MONACO
COACH CORPORATION

VEHICLE SAFETY DEFECT SERVICE BULLETIN

Recall Campaign No. 04V322000

Re: Recall-Windshield Wiper Assembly

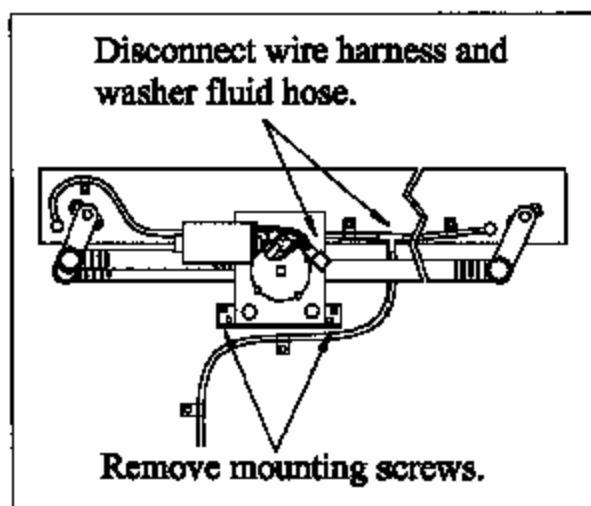
- 1) Remove the dash pad near the windshield & remove the knock out in the board under the dash pad.
- 2) Remove the wiper arms, blades & retaining nuts from the wiper shaft assembly. Remove the fittings for washer fluid.

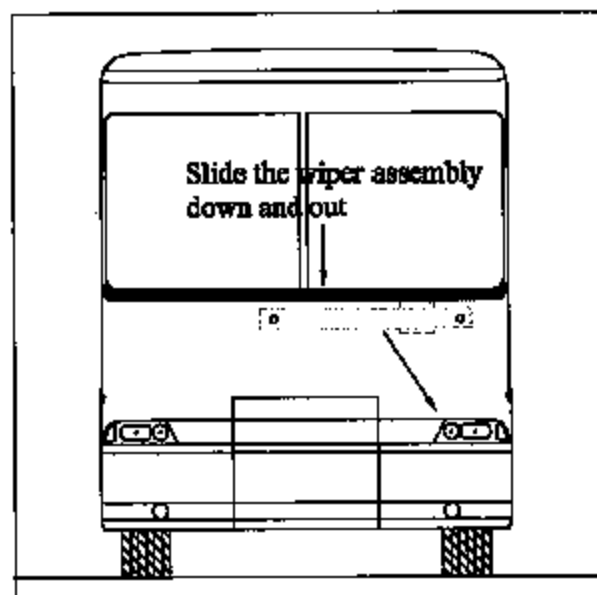
- 3) Remove the retainer screws & bolts for the motor support & disconnect the wiring.

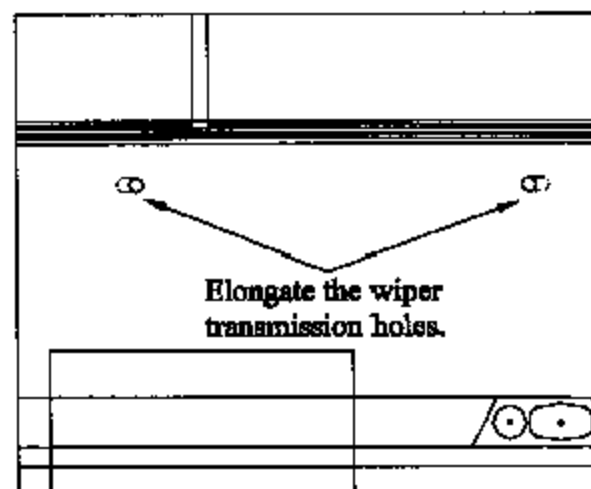
- 4) Pop the assembly free and remove it through the driver side of coach past the generator.

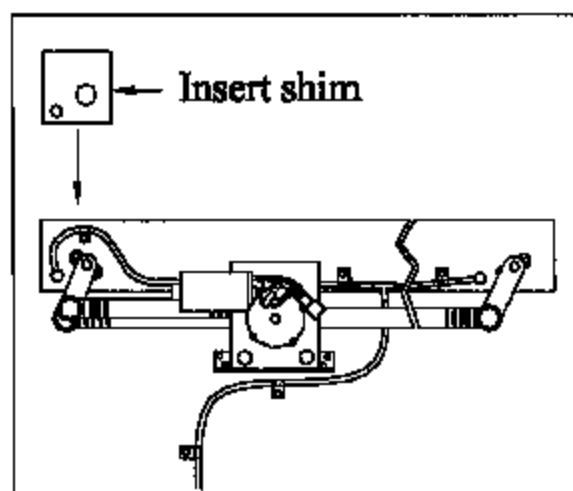
- 5) The holes in the front cap for the transmissions have to be elongated about $\frac{1}{4}$ inch wider to accommodate the wider distance between the shafts.

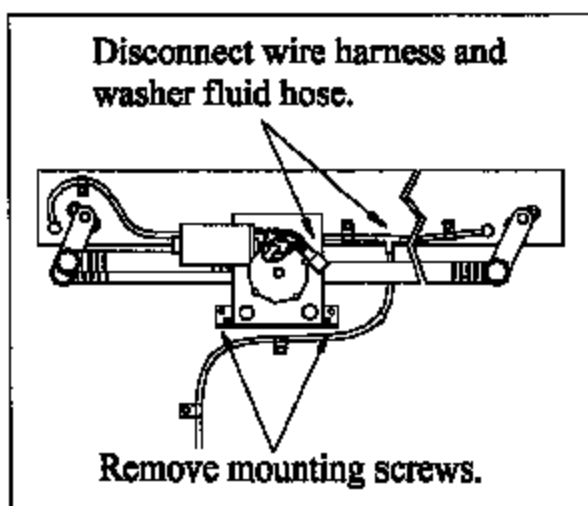
- 1) Remove the dash pad near the windshield & remove the knock out in the board under the dash pad.
- 2) Remove the wiper arms, blades & retaining nuts from the wiper shaft assembly. Remove the fittings for washer fluid.

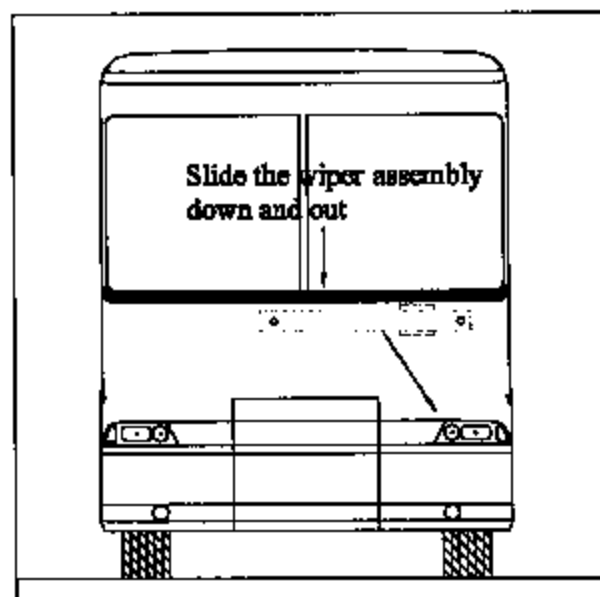
- 3) Remove the retainer screws & bolts for the motor support & disconnect the wiring.

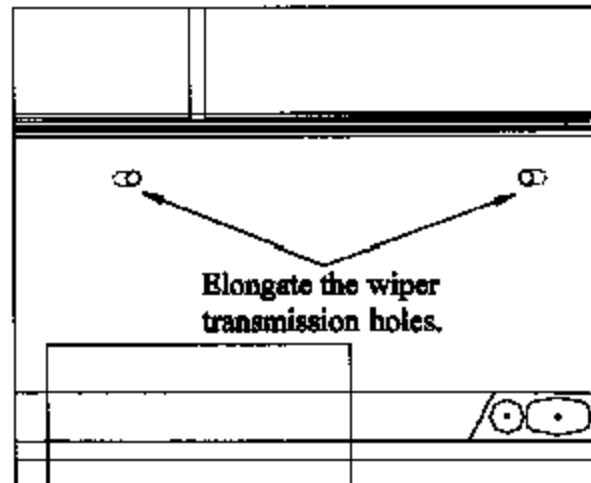
- 4) Pop the assembly free and remove it through the driver side of coach past the generator.

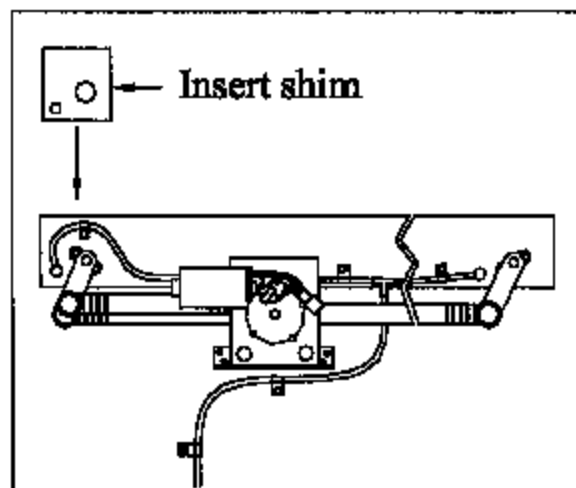
- 5) The holes in the front cap for the transmissions have to be elongated about $\frac{1}{4}$ inch wider to accommodate the wider distance between the shafts.
